Child Care Facilities Capacity Worksheet

County Me Date 7-28-2022
 Facility Strayhorn Preschool & Day Care License No. 6525
 Address 3139 Hwy 4 W Saven MS Maximum/New Capacity 50

Child Care Encounter

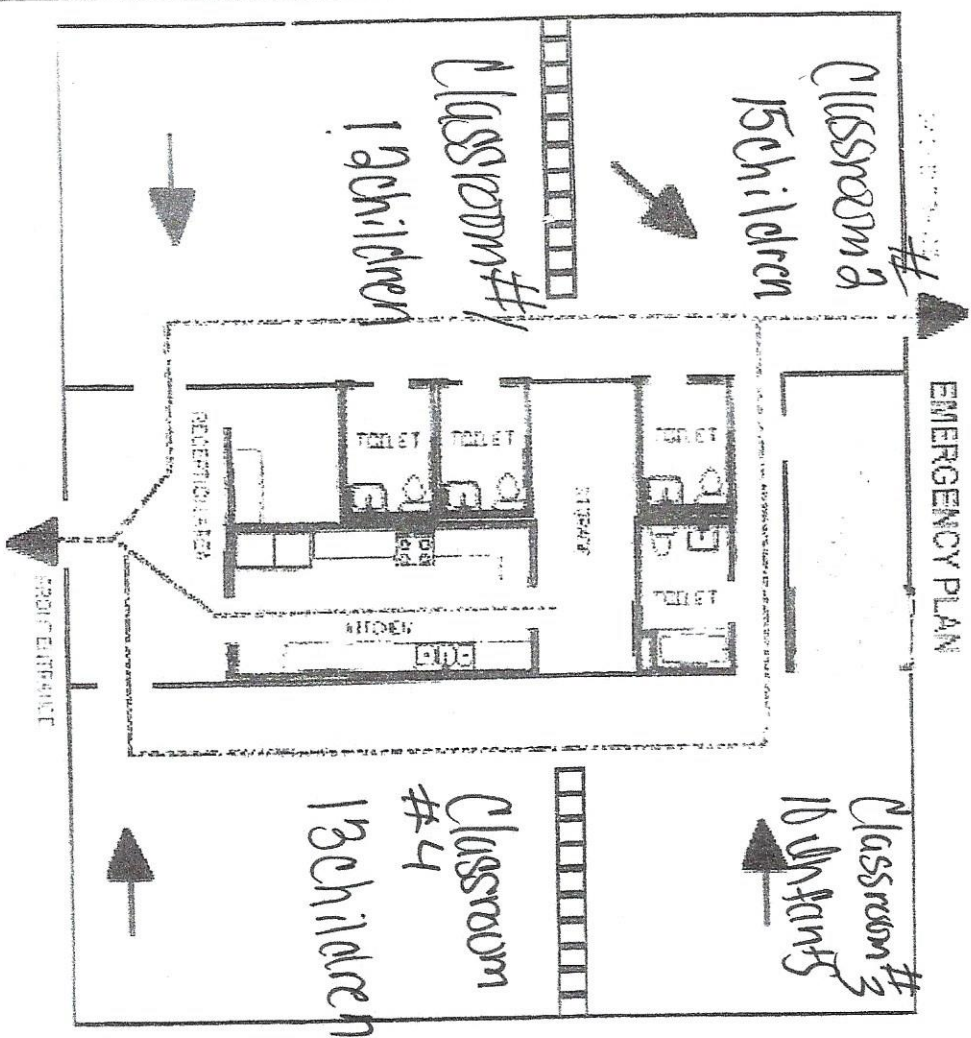
TA was provided for playground II. Supervisor recommended playground fence be extended to prevent children from begin in blind spot. Provider states ~~one~~ potential completion date ~~is~~ before mid-year inspection

Kid Sweets play area was discuss during exit. It was recommended by the supervisor for it to be removed. If not removed it may be counted as another classroom. Provider asked if the door removed could the Kid Sweets play area be used
